DEVELOPMENT REVIEW BOARD REPORT

SUBJECT **Boulders Preliminary Plat**

REQUEST Request to approve preliminary plat for seven residential lots with amended development standards on an 9-acre parcel
14-PP-2003

LANDSCAPE PLAN

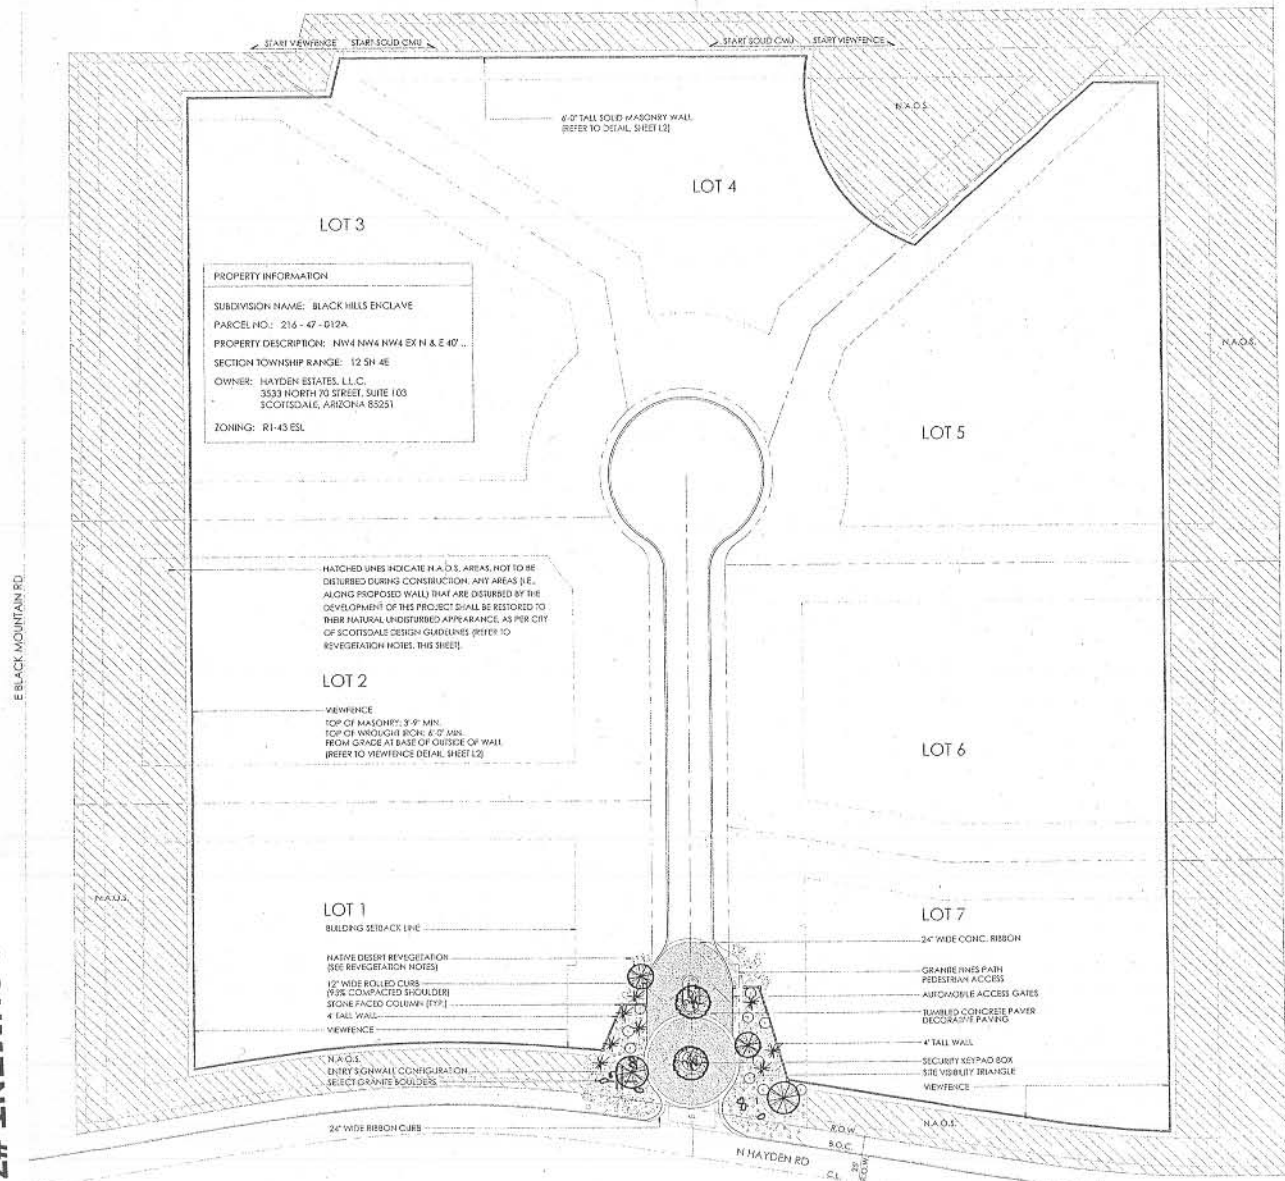
- 1. With the final plan submittal, the developer shall revise the landscape plan to match the approved Development Review Board site plan, to the satisfaction of Plan Review and Permit Services staff.*

- 2. With the final plan submittal, the developer shall revise the landscape plan to show caliper sizes of trees, in lieu of box sizes, to the satisfaction of Plan Review and Permit Services staff.*
